Carlson Software Expands Carlson College

How Does Carlson Support Their Users? Ask David Farina

Here is the original question from David Farina on March 4, 2009:

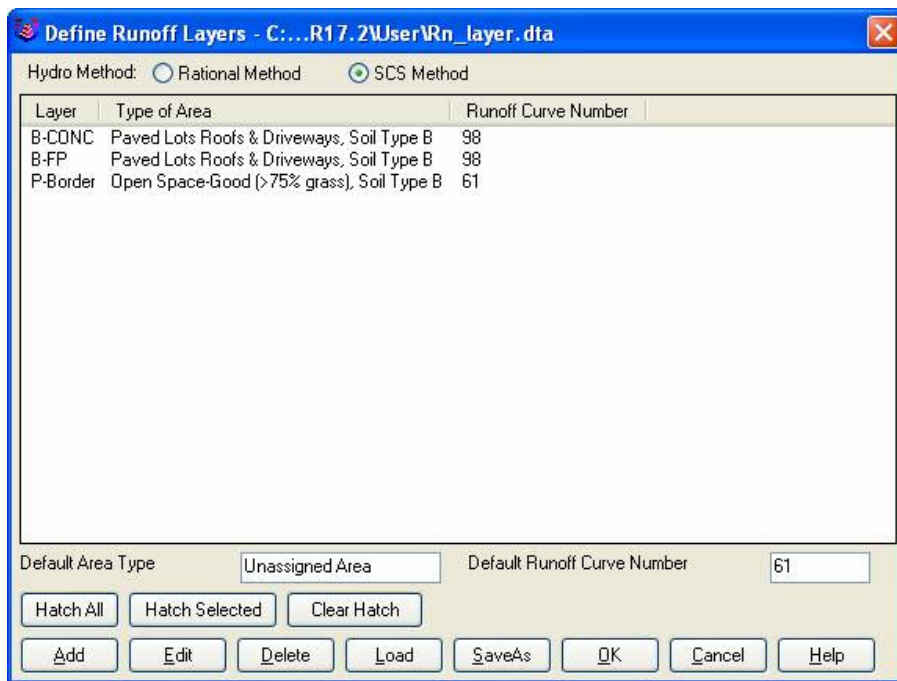
Was the SCS method used to get the 7.1 min value?

Notice the 7.5 value in the TC dialog to the right.

This was the value if I SELECT FLOW LINE FROM SCREEN and pick the path that the dialog on the left generates.

Can I generate a report of how the time to inlet was calculated?

Maybe there can be a button next to the Time to inlet to select TR-55

Maybe Mannings coefficients can also be put into the WATERSHED->DEFINE RUNOFF LAYERS to be used for this calc as the flow path passes through each polyline area the same way Carlson already calculates the composite CN.

For the Storm Sewer Network routine, I put it on the to-do list to add a Select button next to the Tc to show the components that make up the Tc like the Select button does for CN. Also we will look at adding Manning's n to the Define Runoff Layers for use with Tc calcs.
